Access Compliance Report Public Rights-of-Way (Curb Ramps)

Main Street: Foothill_BlvD		Cross Street: SUBURNAS_WY		Location:	SW
ADA ID: RPAT211018084823	Ramp Type:Type 1 - Perpendicular Diagonal Initial Pass/Fail: Fail		Overall Compliance: No	Severity Score:	15
Codes/Mitigation Info/Possible Solution			Field Measurements/Component Compliance

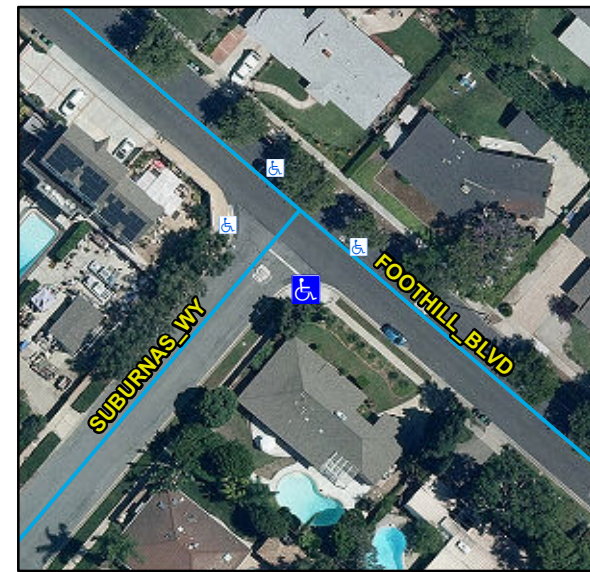
Compliance	Description	Data	Compliance	Description	Data
N/A	Ramp Length (in)	75	N/A	Flare Type LT	
Yes	Ramp Width (in)	49			N/A
No	Ramp Run Slope (%)	9.3	N/A	Flare Slope LT (%)	N/A
Yes	Ramp Cross Slope (%)	0.4	N/A	Flare Traversable LT	N/A
N/A	Landing Present	N/A	N/A	Flare Type RT	
N/A	Landing Length (in)	N/A			N/A
N/A	Landing Width (in)	N/A	N/A	Flare Slope RT (%)	N/A
N/A	Landing Run Slope (%)	N/A	N/A	Flare Traversable RT	N/A
N/A	Landing Cross Slope (%)	N/A	N/A	DWS Provided	N/A
N/A	Landing Movement Obstructed?	N/A	N/A	DWS Contrast	N/A
	Landing Movement Type	N/A	N/A	DWS Length (in)	N/A
N/A	Landing Shared	N/A	N/A	DWS Full Width	N/A
N/A	Clear Space	Yes	N/A	DWS Offset Left (in)	N/A
N/A	Clear Space To Crosswalk (in)	N/A	N/A	DWS Offset Right (in)	N/A
N/A	Marked Crosswalk 1	No	N/A	Marked Crosswalk 2	No
	Crossing 1 Direction	E		Crossing 2 Direction	N
	Marked Crosswalk 1 Width (in)	N/A		Marked Crosswalk 2 Width (in)	N/A

N/A	Ramp Inside Crosswalk 1	N/A	Yes	Ramp Inside Crosswalk 2	N/A
	Crossing 1 Slope (%)	6.6		Crossing 2 Slope (%)	4.4
	Crossing 1 Cross Slope (%)	0.8		Crossing 2 Cross Slope (%)	3.8
N/A	Gutter Ponding	N/A	N/A	Curb Slope	9.3
Yes	Gutter Lip Height (in)	0		Road Run Slope (%)	8.7
N/A	Gutter Run Slope (%)	N/A		Road Cross Slope (%)	1.4
N/A	Gutter Cross Slope (%)	N/A			
Yes	Overall Surface Condition: Acceptable		Yes	Perp Joint Present	Yes
	Cross Gutter Present?	No		Spandrel Present?	No
	Replace Cross Gutter?	N/A		Replace Spandrel?	N/A

Remove & Replace Curb Ramp With Two New Directional Ramps or Equivalent.

R304.2.2, STD 1115
